NORTHERN STATES POWER COMPANY

PRAIRIE ISLAND NUCLEAR GENERATING PLANT  
Docket Nos. 50-282      License Nos. DPR-42  
                  50-306                      DPR-60

## Auxiliary Feedwater Systems

REVIEW OF NRC RECOMMENDATIONS  
RELATED TO PRAIRIE ISLAND AFW SYSTEMS

Auxiliary Feedwater System  
 Prairie Island  
 Figure 1

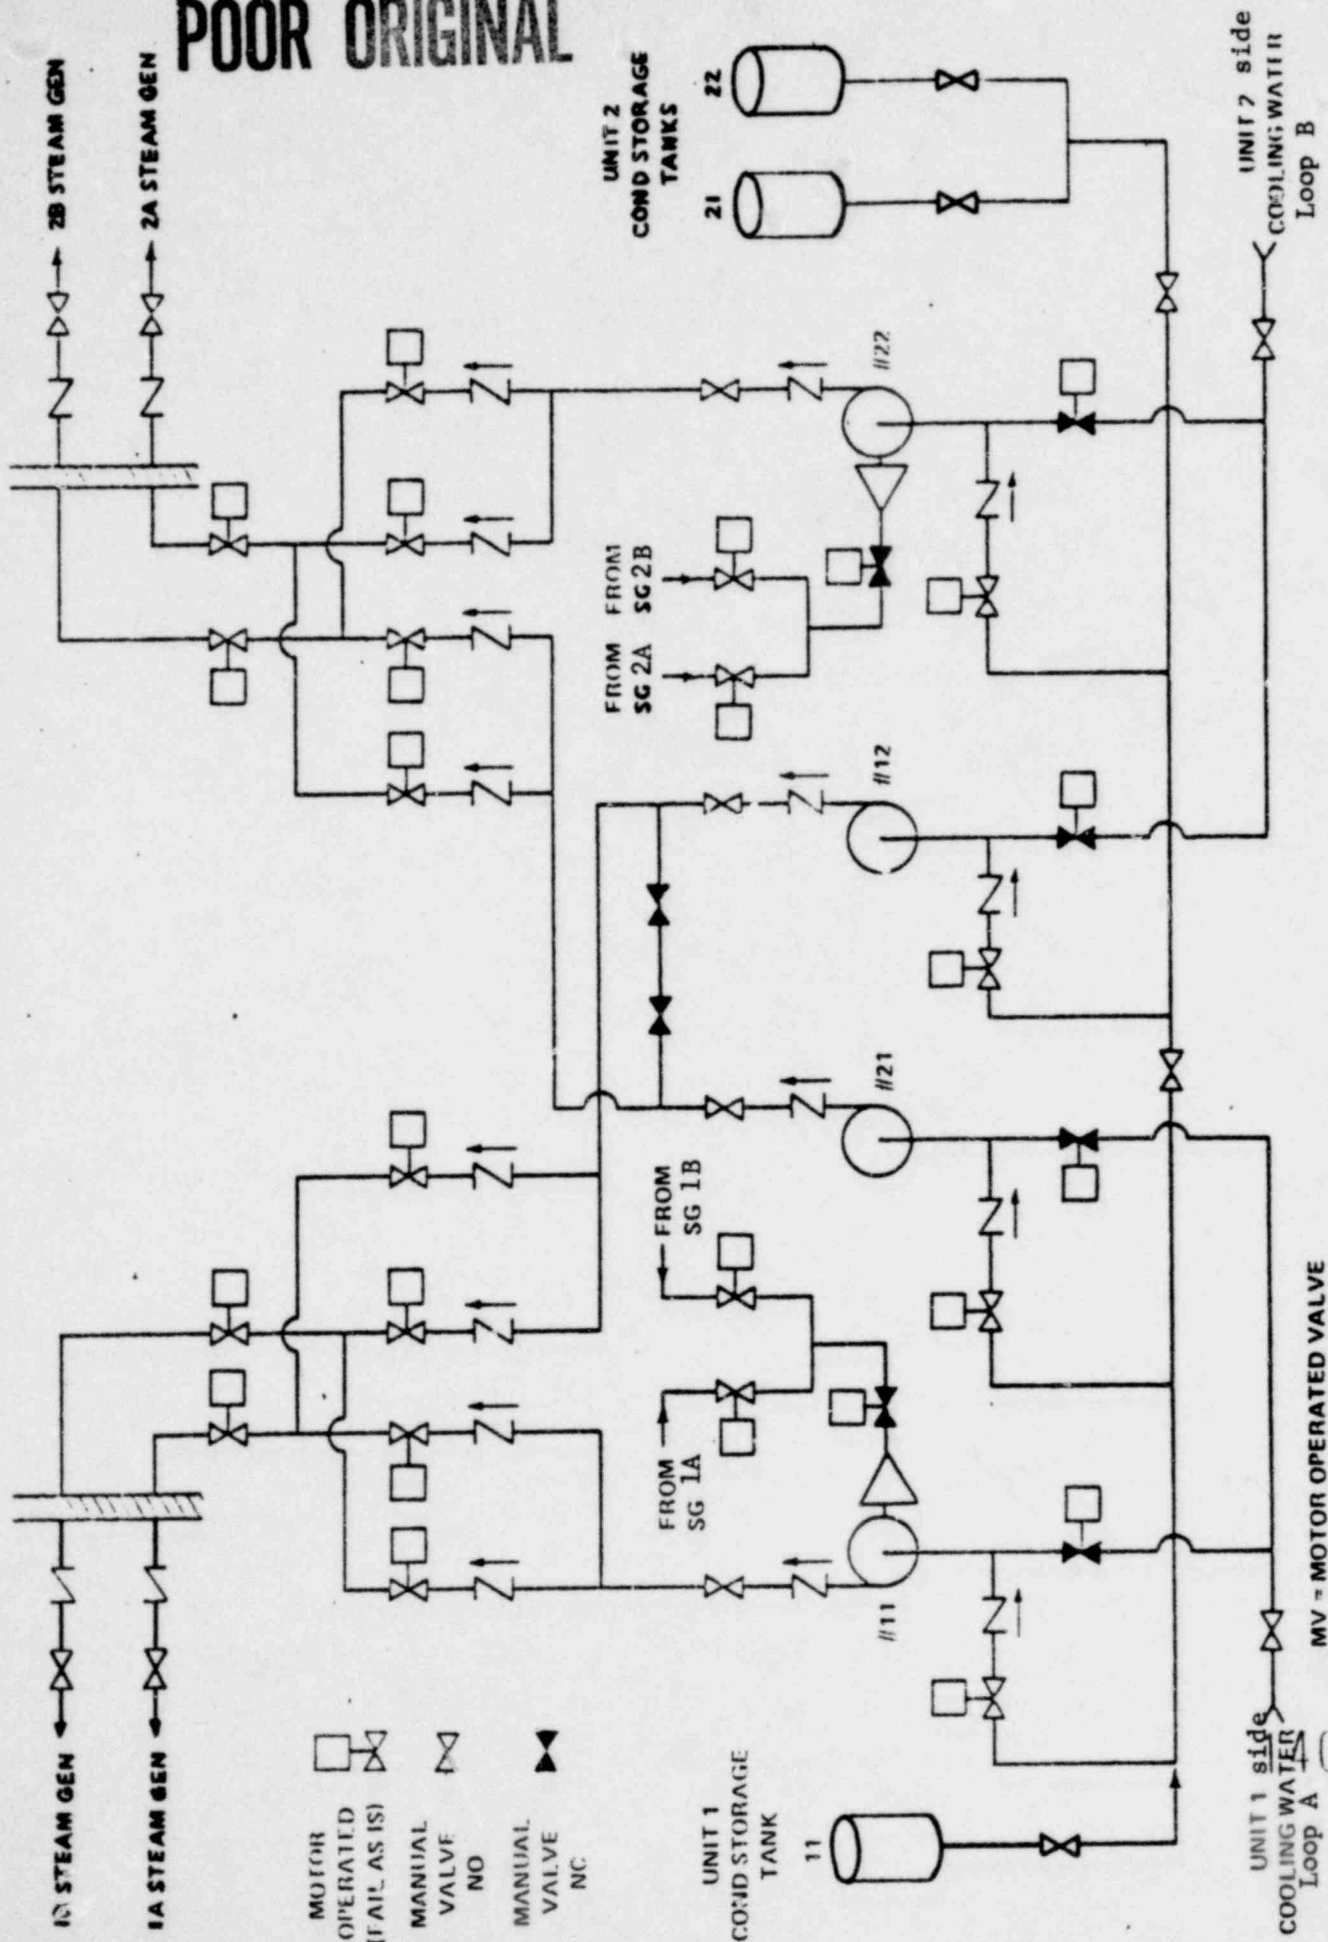
"Licensees having plants with unprotected normal AFW system water supplies should evaluate the design of their AFW systems to determine if automatic protection of the pump is necessary following a seismic event or a tornado. The time available before pump damage, the alarms and indications available for the control room operator, and the time necessary for assessing the problem and taking action should be considered in determining whether operator action can be relied on to prevent pump damage. Consideration should be given to providing pump protection by means such as automatic switchover of the pump suction to the alternate safety-grade source of water, automatic pump trip on low suction pressure or upgrading the normal source of water to meet seismic Category I tornado protection requirements."

The normal source of water, the condensate storage tanks, do not meet seismic category I tornado protection requirements. There is redundancy of these tanks as shown in Figure 1. It is unlikely that the seismic or tornado event could affect all 3 tanks because of location.

AFW pump suction protection is a valid concern. For this reason, we are investigating the various options available, one of which is to install a low suction pressure trip for the AFW pump. Such a design change might include a control room alarm.

FIGURE 2

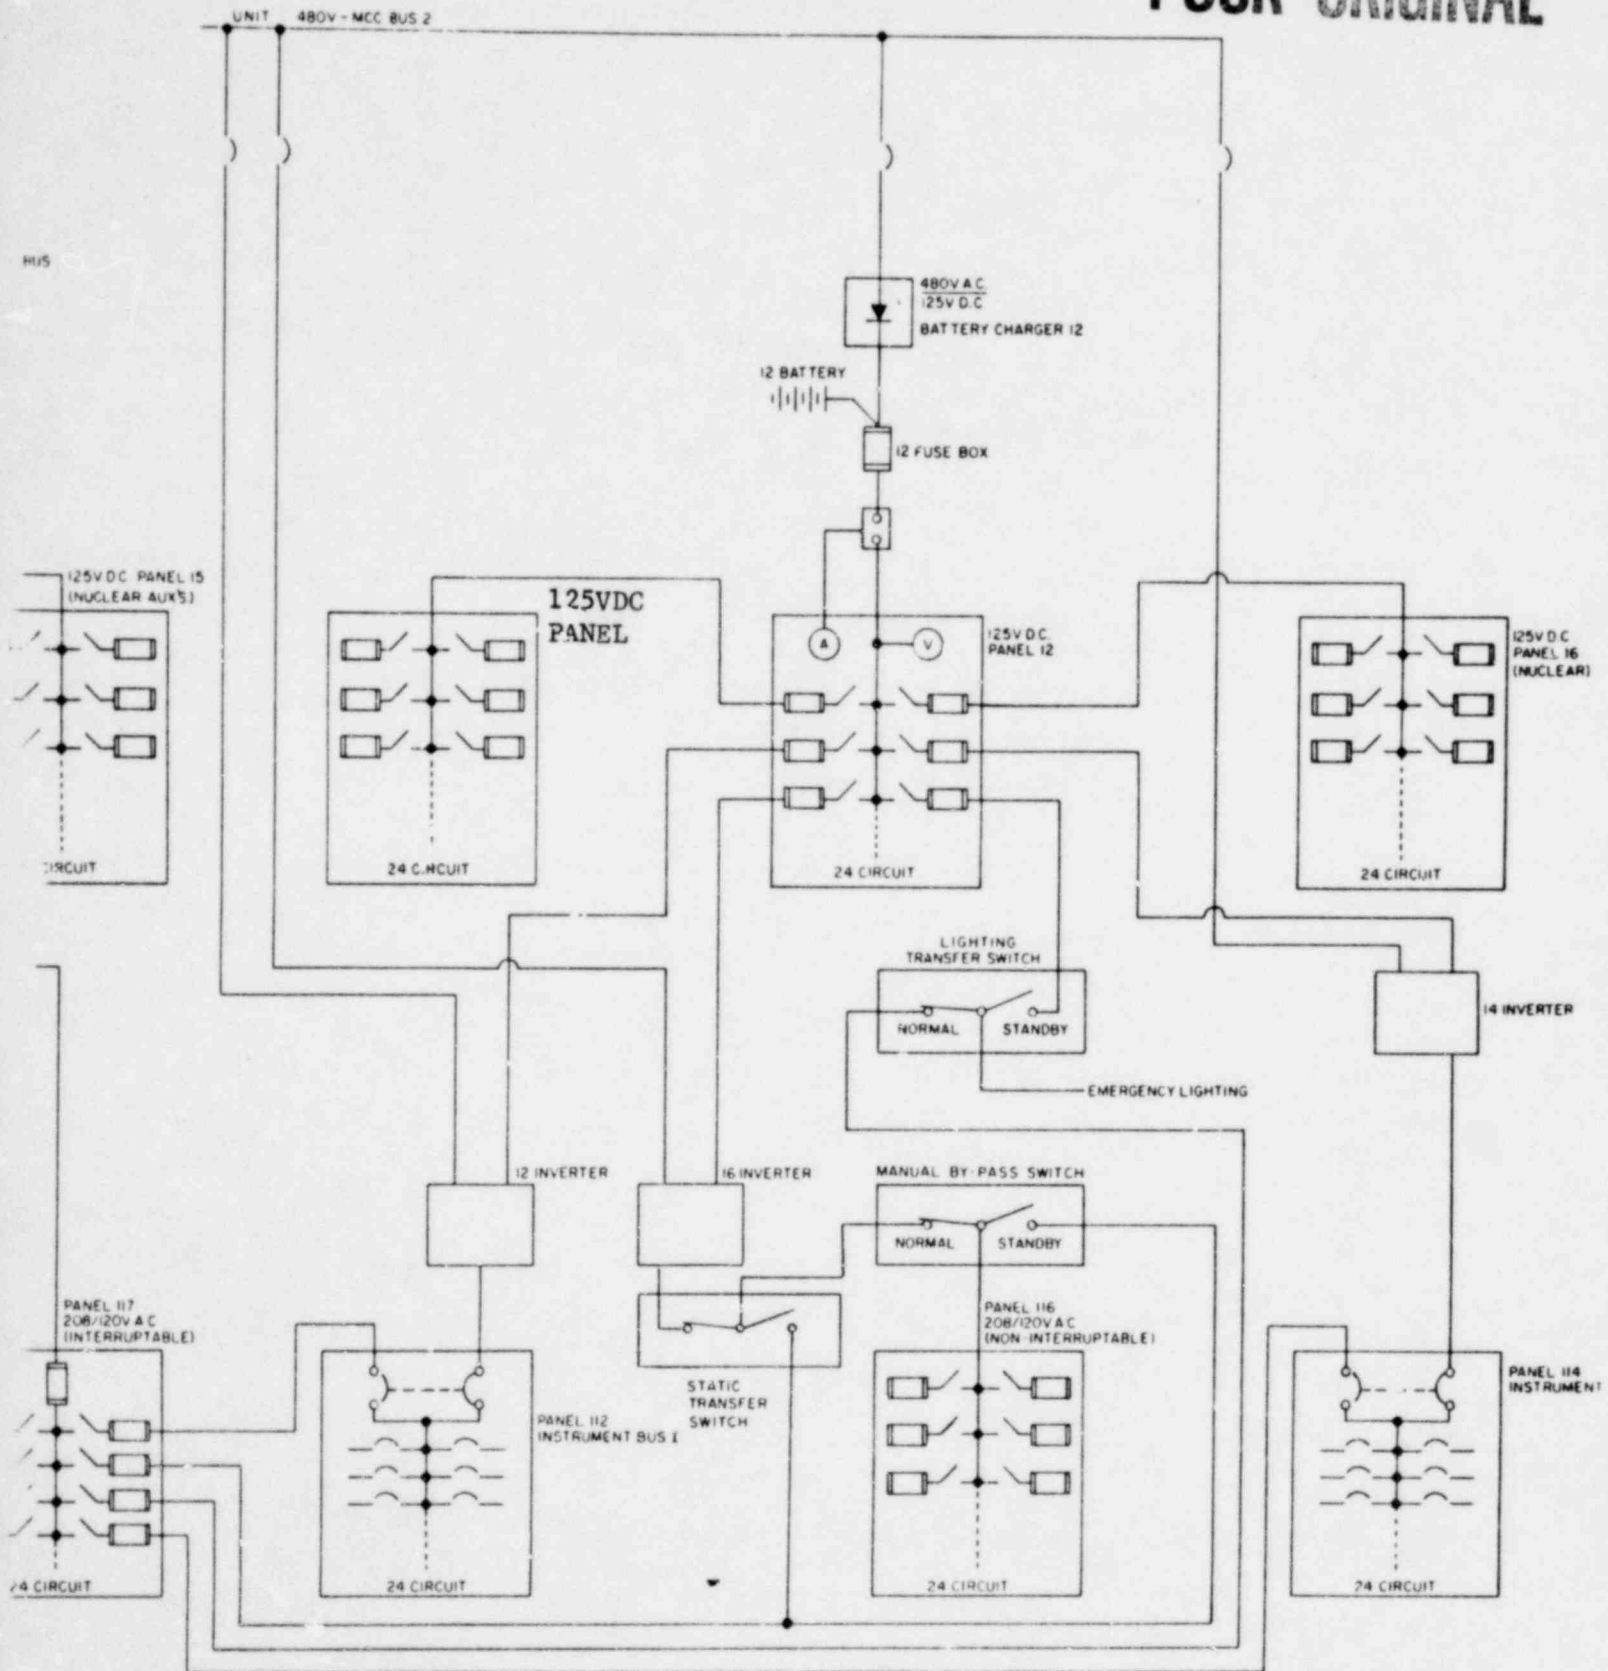
The as-built plant should be capable of providing the required AFW flow for at least two hours from one AFW pump train independent of any alternating current power source. If manual AFW system initiation or flow control is required following a complete loss of alternating current power, emergency procedures should be established for manually initiating and controlling the system under these conditions. Since the water for cooling of the lube oil for the turbine-driven pump bearing may be dependent on alternating current power, design or procedural changes shall be made to eliminate this dependency as soon as practicable. Until this is done, the emergency procedures should provide for an individual to be stationed at the turbine-driven pump in the event of the loss of all alternating current power to monitor pump bearing and/or lube oil temperatures. If necessary, this operator would operate the turbine-driven pump in an on-off mode until alternating current power is restored. Adequate lighting powered by direct current power sources and communications at local stations should also be provided if manual initiation and control of the AFW system is needed.

During events such as a loss of all AC emergency lighting would be provided from the Class 1E DC distribution system (Figure 2).
